Schematic Name: SCHEMATIC1			
Page Title: PAGE1		Engineer: <Engineer>	
Project Name: <Project Name>		Designer: <Designer>	
Group Name: <System>	System: <System>	Subsystem: <Subsystem>	Last Updated By: <Updated By>
Drawing Number: <MBARI DN>	Release: <Rev>	Version: <Version>	Status: <Status>
Page Modify Date: Monday, April 11, 2022	Check In Date: <LCID>	Sheet 1 of 2

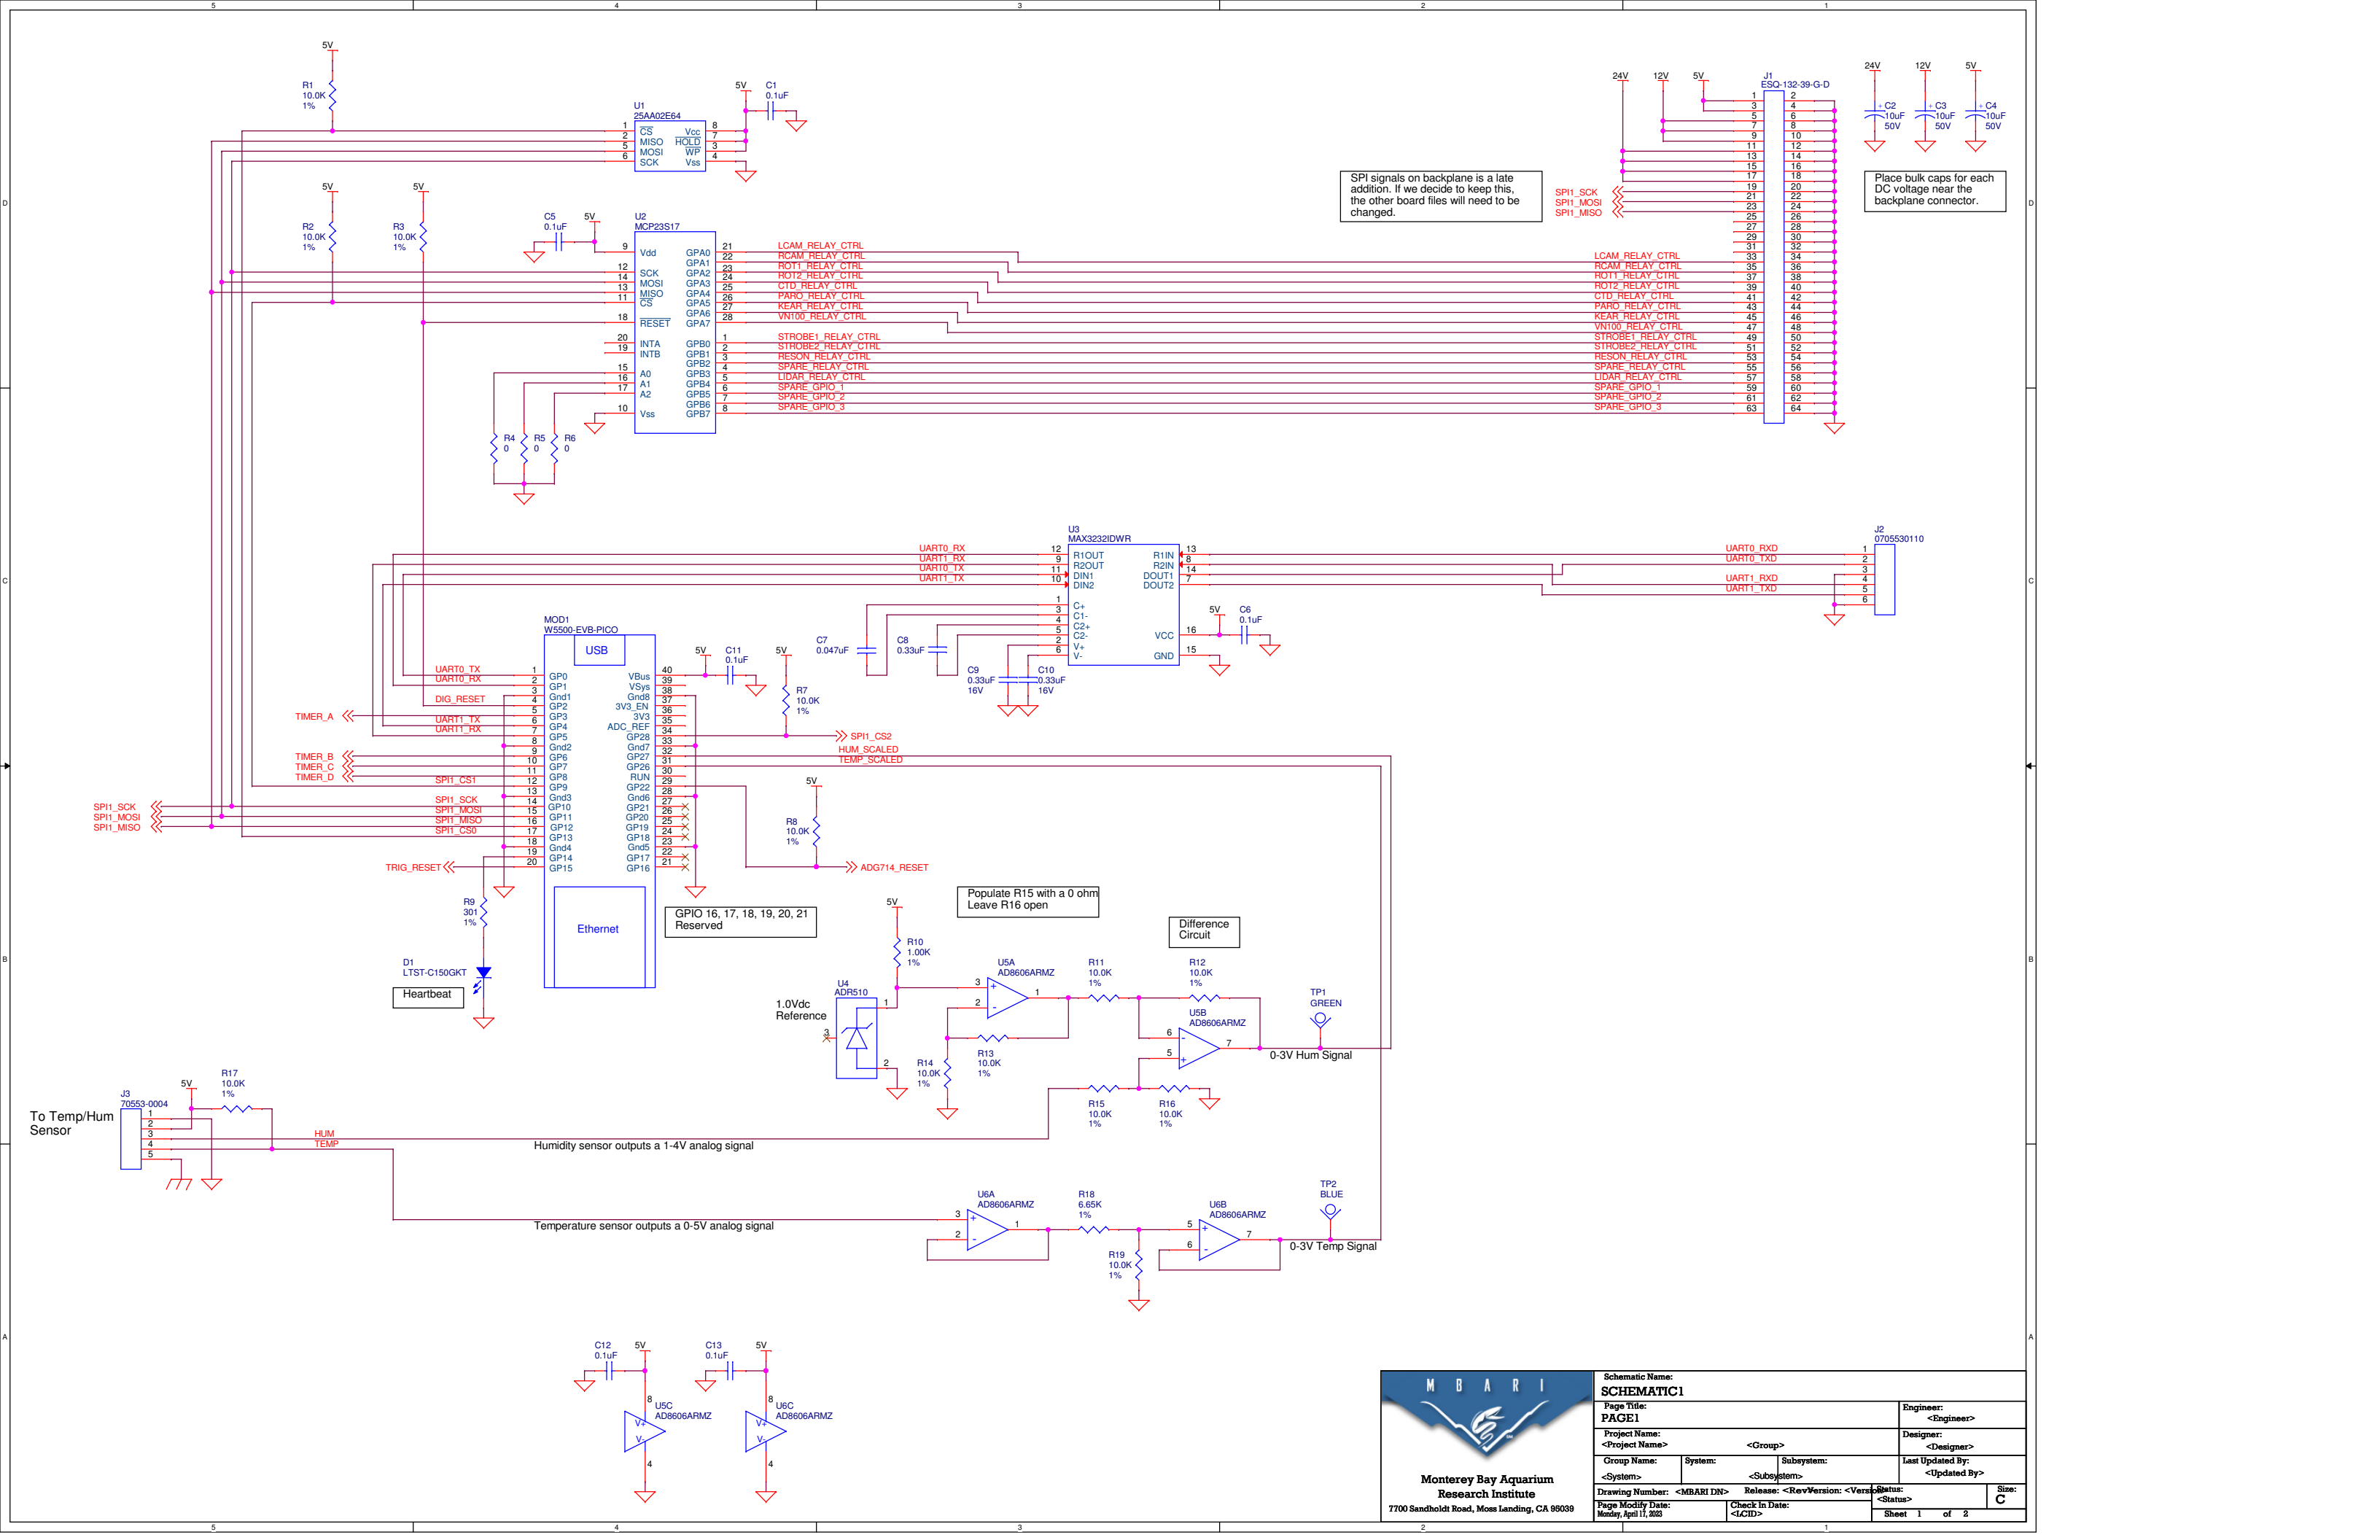
SPI signals on backplane is a late addition. If we decide to keep this, the other board files will need to be changed.

Place bulk caps for each DC voltage near the backplane connector.

Populate R15 with a 0 ohm
Leave R16 open
